Request for Permission to Undertake Structural or Visual Alterations

Building Number and Name: Landscaping Work – 60 % of the facility/Site

17-M36

REPLACE DOMESTIC FIRE AND WATER MAIN

S2.4

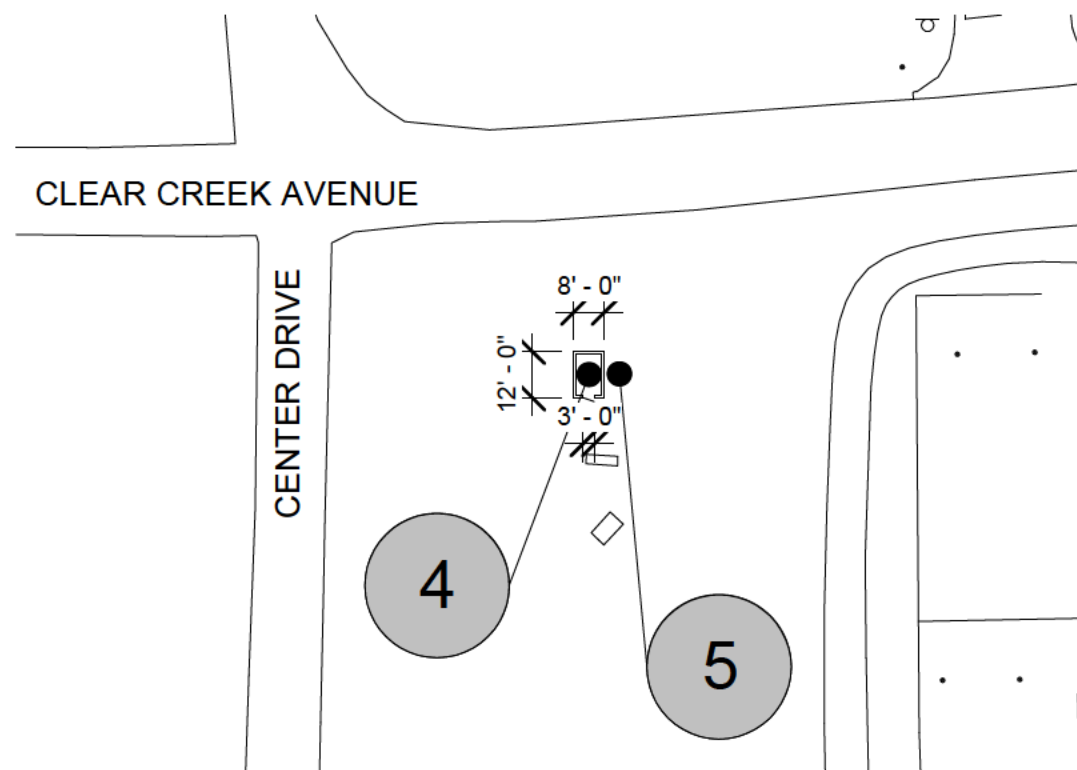
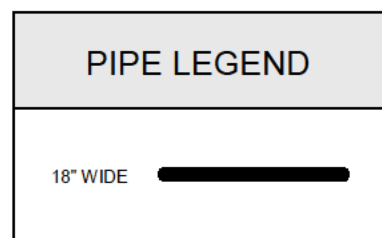
- Sheets S2.1 and S2.2: Provides a reference point for the photographs on Sheet S1.2.
- Sheet S2.4: This drawing shows where we will cut into the existing Clear Creek water supply pipe where it enters the property at Gibson and Center Drive. The pipe is approximately 4 to 5 feet deep at this location. We will install parallel 6-inch water pipes from the Clear Creek pipe cut location to the existing Well at the corner of Clear Creek and Center Drive. Question: Will this excavation require an archeologist?

- Sheet S2.4: Conex Box rendering. The rendering is not as good as the actual building will be. The concept is to purchase a new one-half Conex box (8 feet by 10 feet x 9 feet high) with a standard man door. The wrap will be generated from a current high-quality photograph of Building 90 rock exterior. This photograph will be used to make a full-size wrap to be installed on the building. The purpose of the conex/portable building is that in the next 30 years the well could be abandoned, and the portable building can be picked up and moved off site. SPWD has not conducted a building wrap before; however, we have all seen wraps on cars that appear very realistic and the rock wrap should provide an excellent visual for this location as a lead into the Stewart Facility.

Architecture: We are okay with the Conex concept given the location; however, we have concerns about the proposed exterior finish. The building vinyl wrap concept will not be compatible with the existing historic district, as is not an appropriate exterior finish for the campus and, as such, will not meet the Secretary of Interior's Standards. Instead our office suggests painting the building a taupe/beige color to blend in with the ground color at that location. Additionally, as the rendering shows roof fascia and a white door, all those elements should also be painted the same beige color.

Archaeology: We have some questions regarding the irrigation wire control excavation depth. The submitted materials note that grass has been replaced and the area is disturbed in the past. How deep has that area been previously disturbed? Since 5 inches of grass removal will basically be just the root system of the grass, we would like to know if the wire actually needs to be buried deeper than that? Once we have more information, our office will be able to confirm whether or not an archaeological monitor is needed for this activity. Please note that our office believes an archaeological monitor should be present for excavations for water supply at Clear Creek/Gibson/Center Drive area.

Architecture: The Conex building should be painted a taupe beige color to blend in with the ground color at that location, in addition to the roof fascia and white door. For additional information, please see email correspondence from the SHPO to Ken Scarborough dated April 16, 2021.

Archaeology: Please note that an archaeological monitor should be present for excavations for water supply at Clear Creek Gibson Center Drive area and where wires are to be buried in Zone 4.

Archaeology: Our office seeks clarification on what you mean by “concurrence for archaeological survey,” as we only recommended an archaeological monitor. This must be clarified before our office can sign off on this project and forward to the other agencies. Please note that our office finds archaeological monitoring will only be necessary for the deeper area and not the wire installation.

Painting the conex as recommended can be completed and all efforts will be made to make it blend in. I will put in the specifications additional funds for painting that your office can inspect once we get one side painted and provide input (different shade/color scheme/pattern). If we need to make modifications, those funds will already be built into the contract and will not require a change order or outside approval. Project Manager will have authority to modify in the field.

IRRIGATION CONTROL ZONES

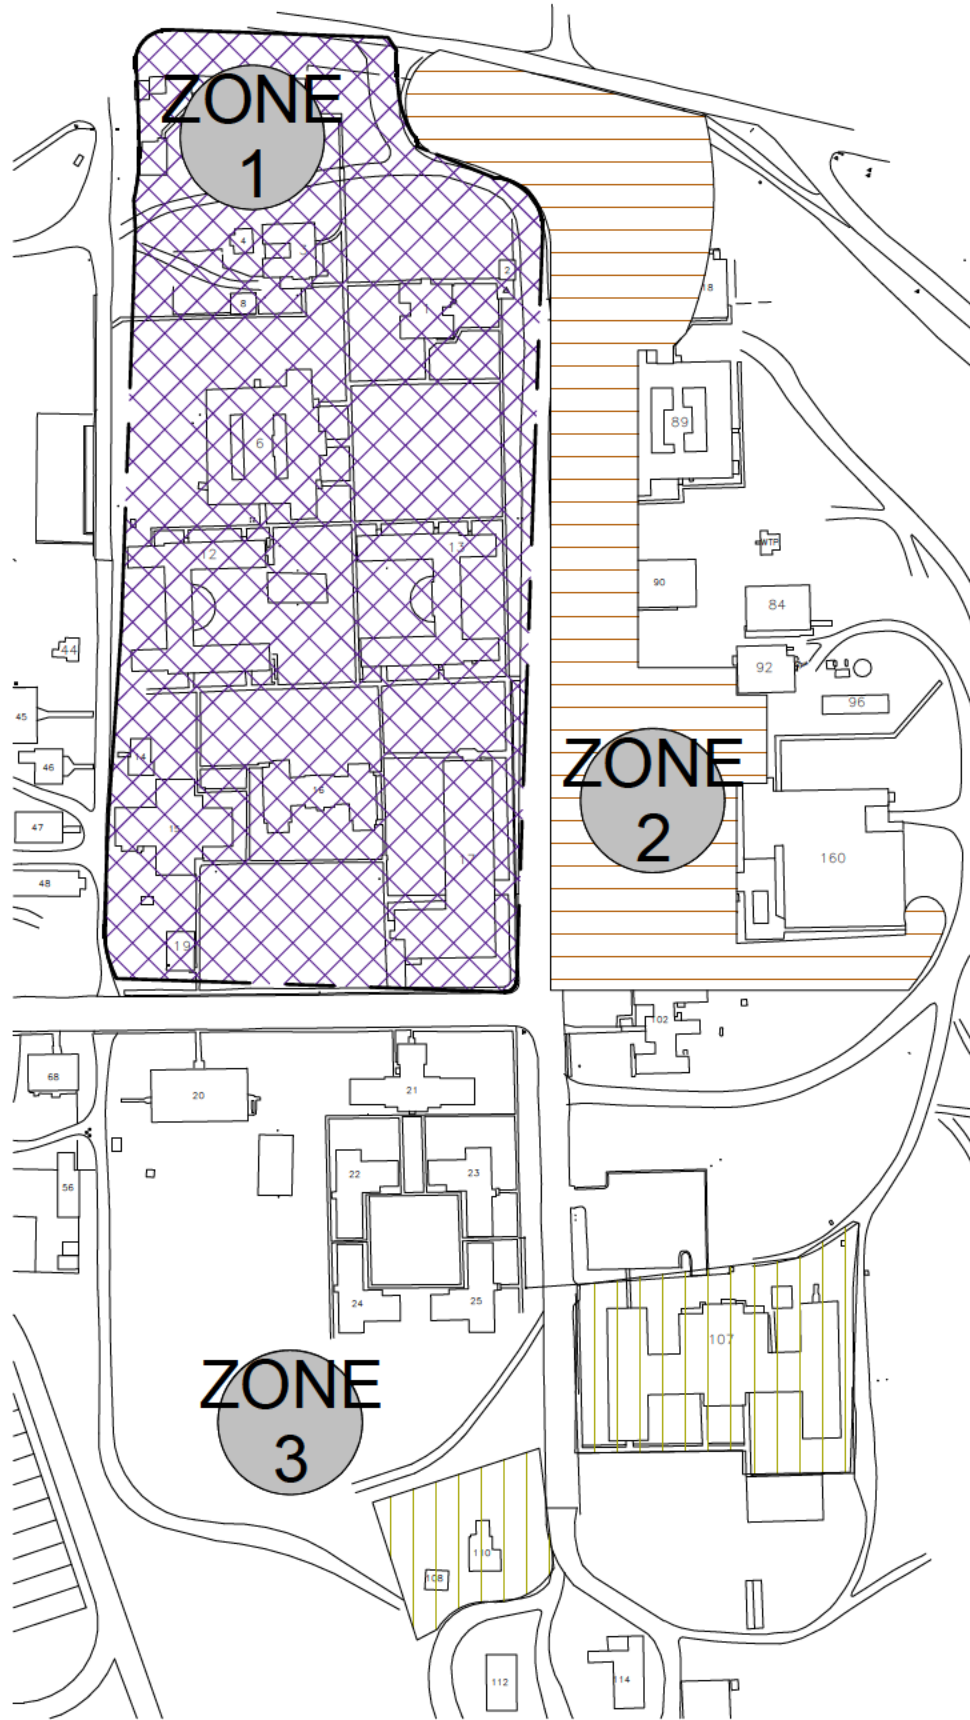
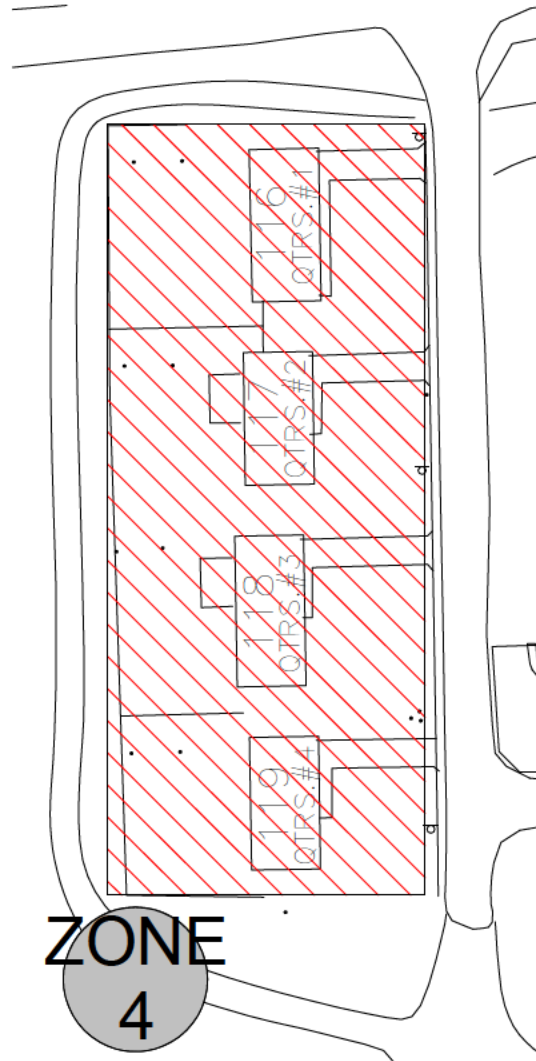
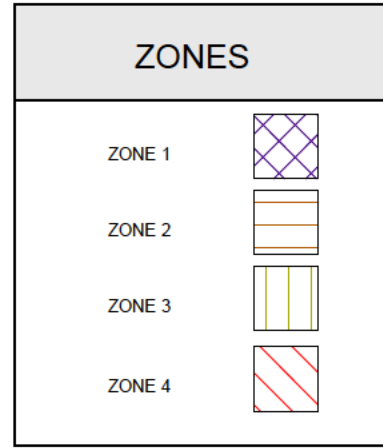
- Sheet S3.0: Inside the zones we will need to trench a total of 10,000 linear feet to install the irrigation control wire for the new clocks. This will be a VERY small trench 2 inches wide and 5 inches deep. Since the grass has been replaced before we believe that all this area has been disturbed/replaced in the last 30 years and should not require an archeologist.

Please clarify if these additional wire routes have been previously disturbed (grass removed and previous sprinkler installed).

In reviewing the drawings there are two additional locations that wire will be routed.

- Zone 3: A wire will have to be routed between the two separated sections of Zone 3.
- Zone 4: A wire will be routed from one of the backyard/west side of the four houses back to the small building being placed in the well area.

Our office would like confirmation that work will not occur beyond the zones as shown in the revised drawings. Can you please clarify that work, such as wire trenching, will not occur beyond the zones (in general) and in respect to Zones 1 and 2 as their boundaries have been reduced?

Thank you for this clarification. The SHPO would not recommend an archaeological monitor for Zone 3 as it is located within and existing road.

The SHPO would recommend an archaeological monitor is present for excavation work in Zone 4.

Zone 3 is disturbed. We will be cutting across an existing road.
Zone 4 most likely is not.

- Zone 1 was decreased to not include the northwest corner property. The State does not own it.
- Zone 2 was decreased because we do not own a small strip along the south edge of Snyder Avenue or the north part of Zone 2.
